9319 SNOW RIDGE LN

INSPECTION OF ENGINEERED SUBSURFACE WASTEWATER SYSTEM

Re: Property located at 9319 Snow Ridge Lane
Tax Parcel #141-111-33

Receipt of the plans and specifications for a conventional system of sewage disposal for the primary system and a Prefabricated, Permeable Block Panel System (PPBPS) proposed as the future repair system is hereby acknowledged. Upon receipt of the information, a review was made of the material on file and a site evaluation was conducted. The plan was then reviewed in conjunction with provisions of 15A NCAC 18A .1900, "Laws and Rules For Sanitary Sewage Collection, Treatment and Disposal". Our comments are listed below:

PROPOSED PLOT PLAN

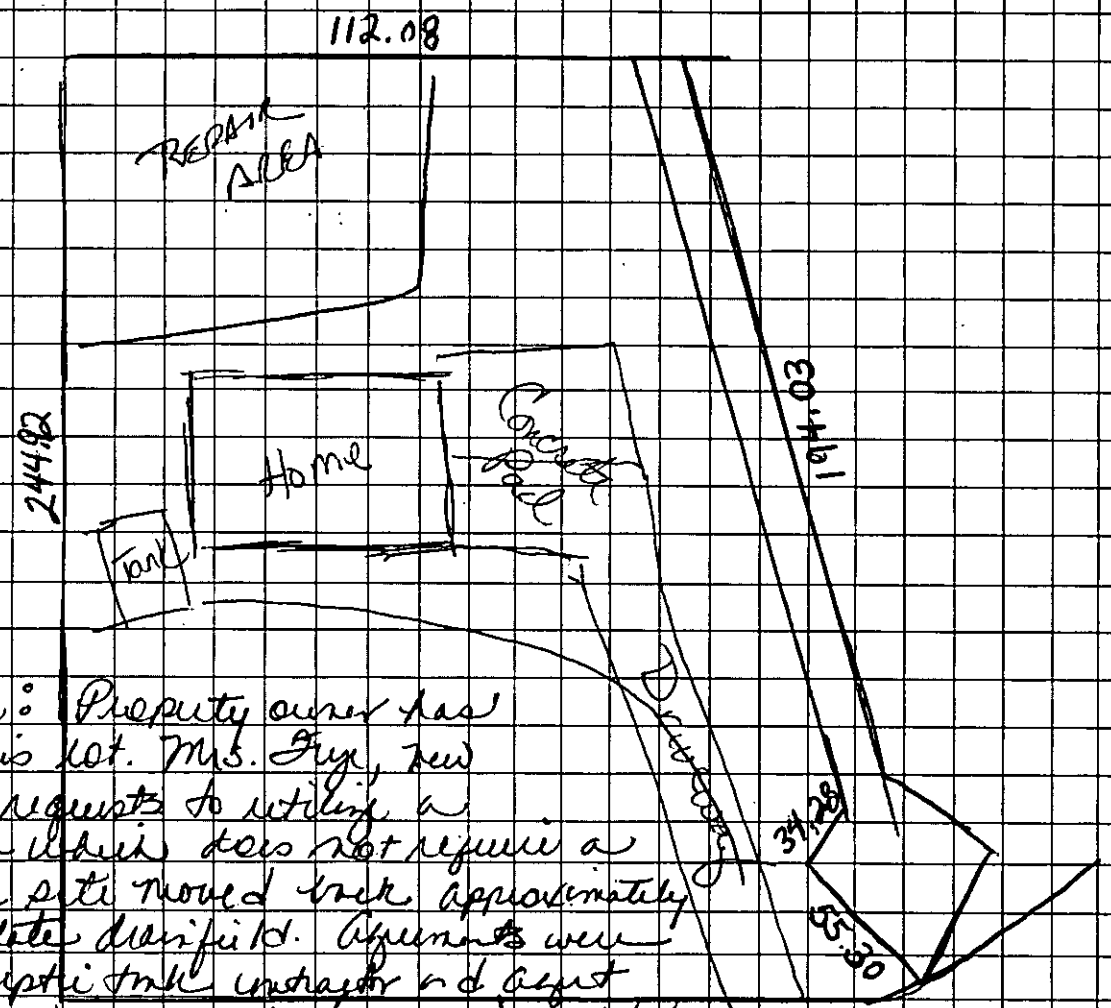
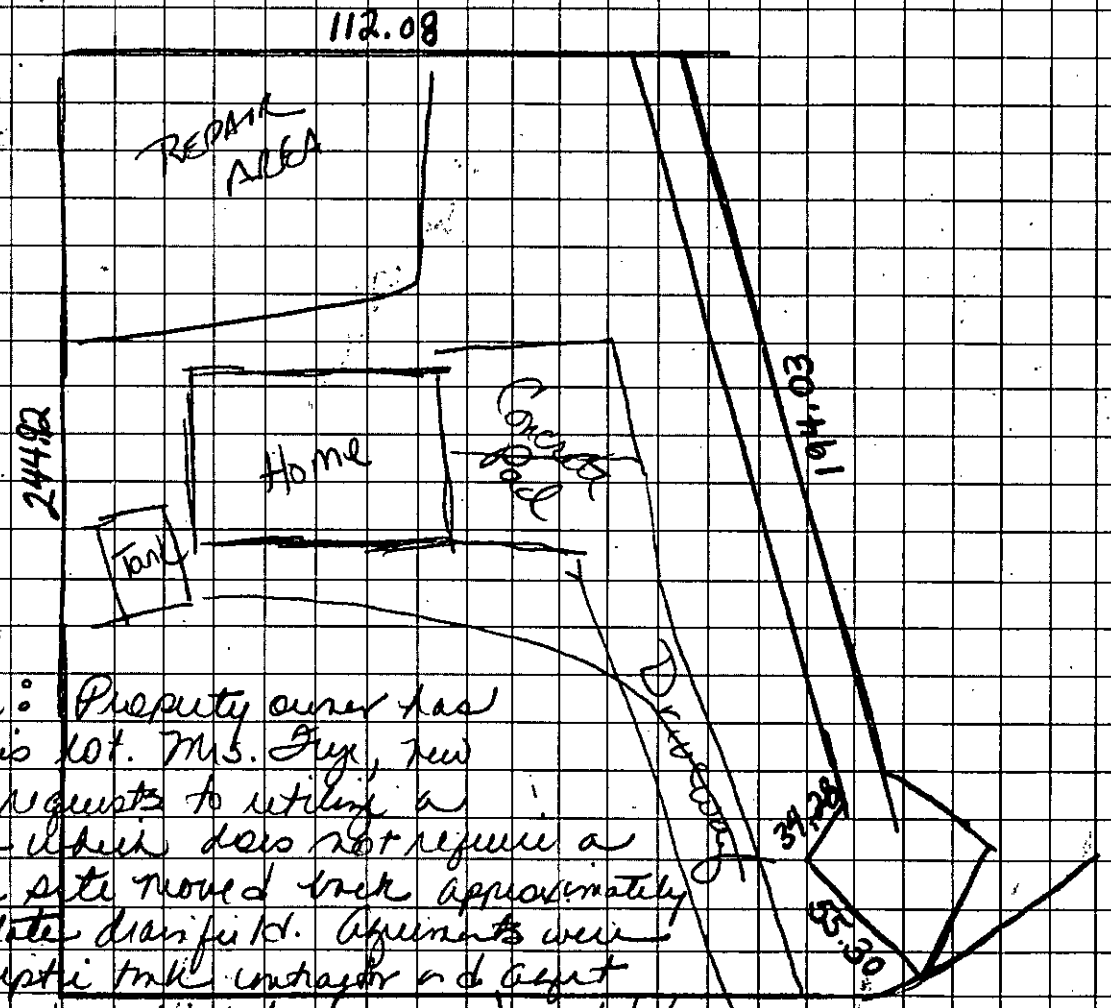
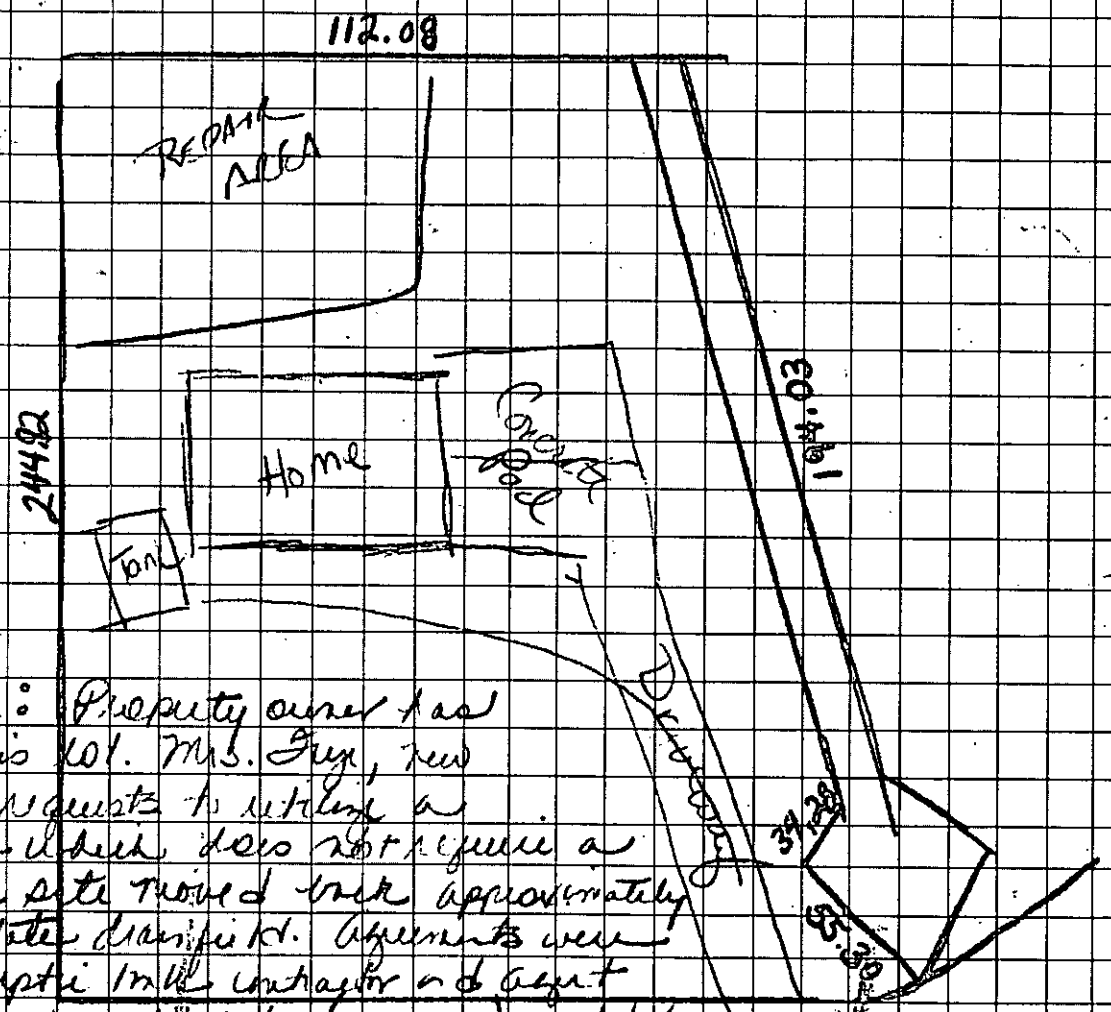
Note to file: Property owner has changed on this lot. Mrs. Fix, new property owner requests to utilize a septic system which does not require a pump. House site moved back approximately 100' to accomodate drainfield. Agreements were reached by septic tank contractor and agent that house site & septic tank (193.26) would be set to insure gravity flow to tank. 25% Reduction/ INNOVATIVE would be required to be used due to site & space limitations and repair of PABBS in back of lot.

PROPOSED PLOT PLAN

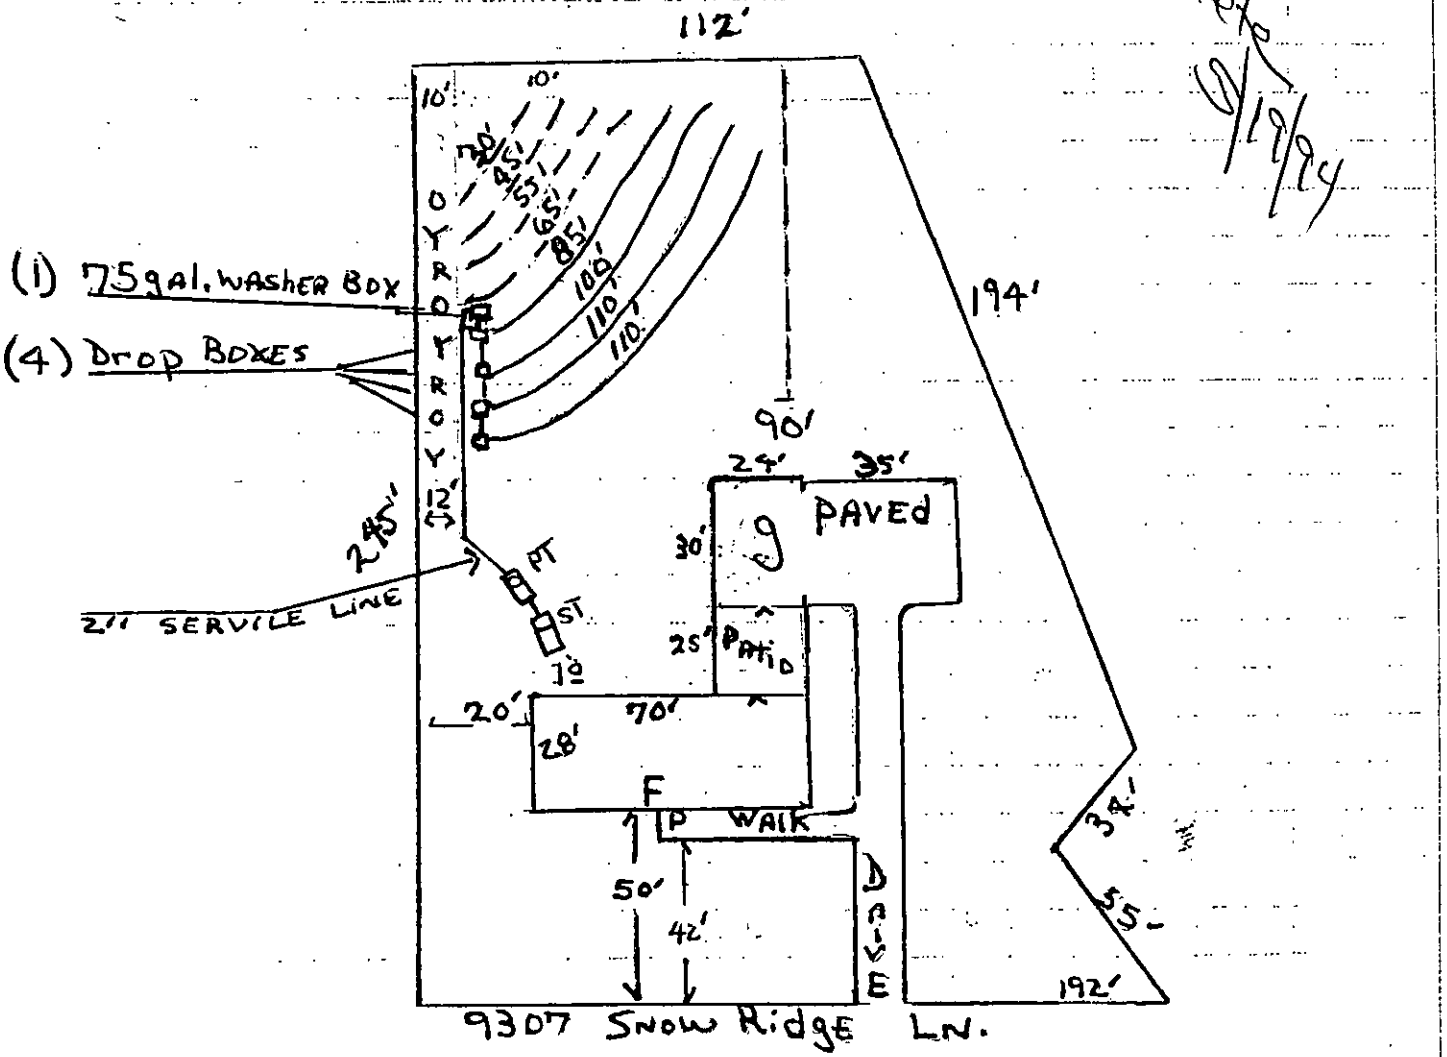
1. The proposed layout is not a desirable design. Both the conventional system and the panel block system are stacked on the hillslope which could cause a strain on the soils permeability and cause a failure from hydraulic overloading. According to the design criteria required by the designer-manufacturer of the panel block system, the system as it is staked out on the lot, creates a "Window Effect," which is unacceptable according to construction requirements as outlined in their construction manual.

2. No provisions have been allowed for interceptor/surface drainage ditches which are required to divert both surface and lateral water movement away from the drainfield. This would further reduce the available land space for the system as is designed.

Possible alternatives for system location would be to locate a conventional system on the back of the lot and designate an area at the front of the property as the repair area using a conventional system . Or, you may locate the house back further into the lot, propose a conventional primary system at the front and a panel block system at the rear of the lot as the repair system.

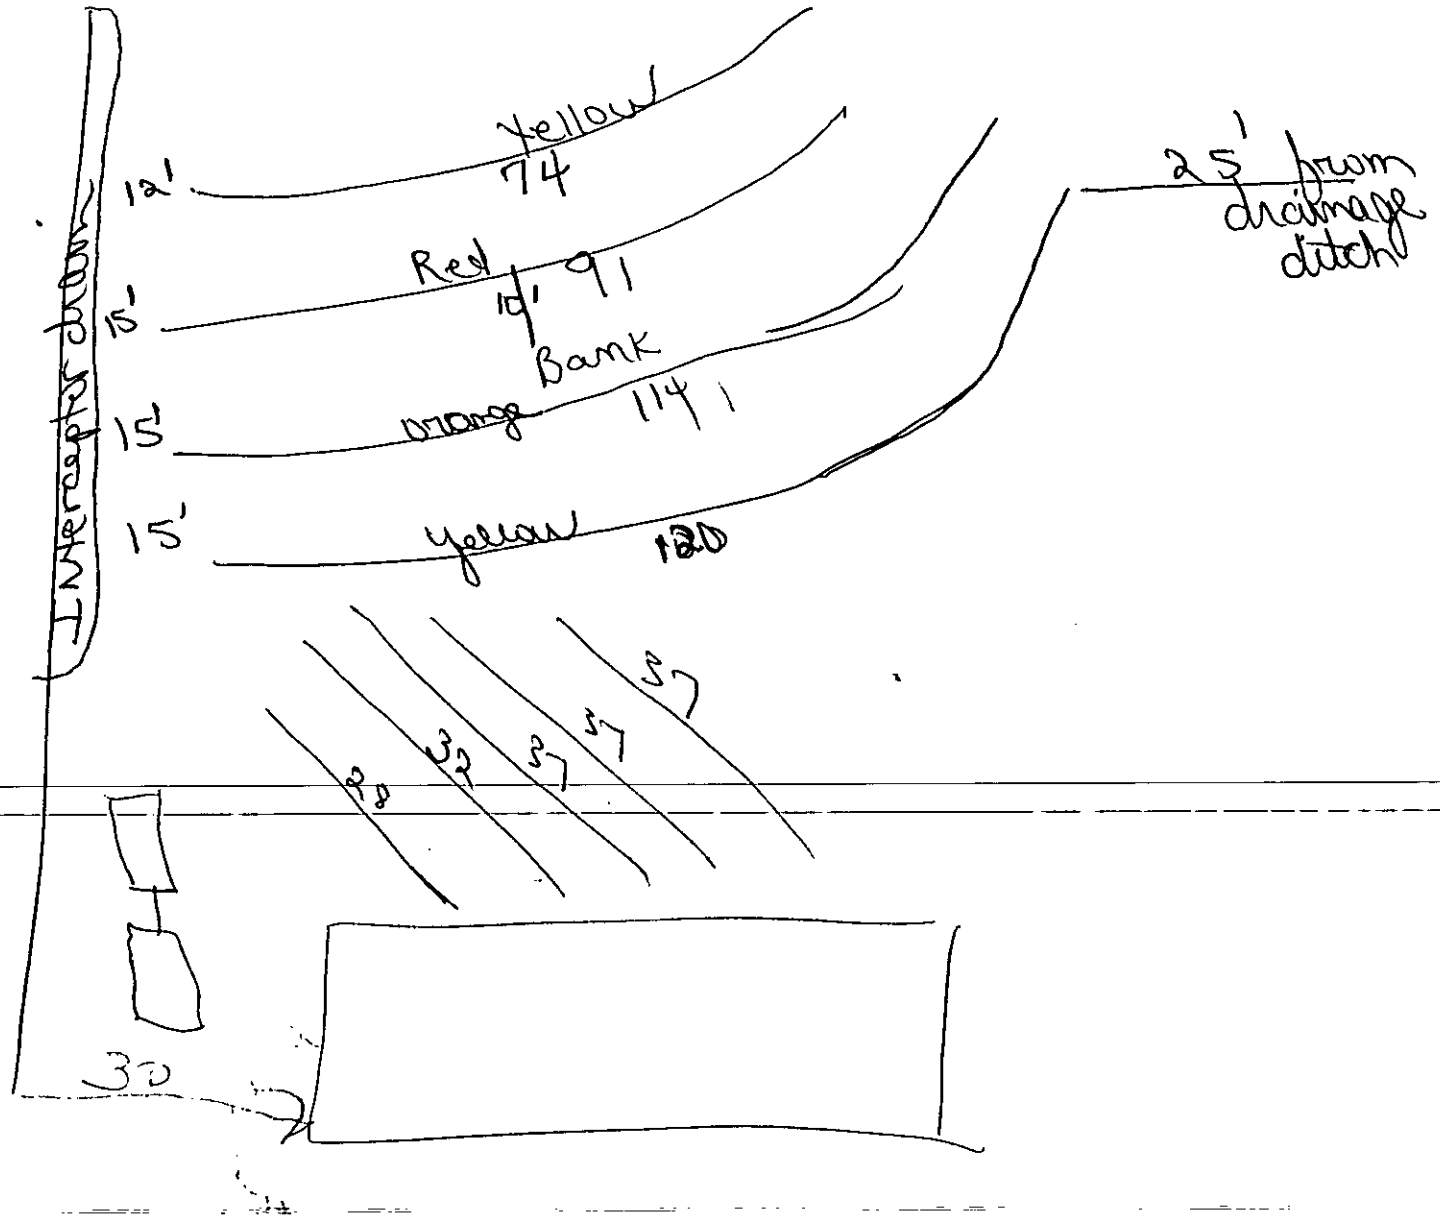
(1) Move house downhill to 30' off Left Line
Now at 21'
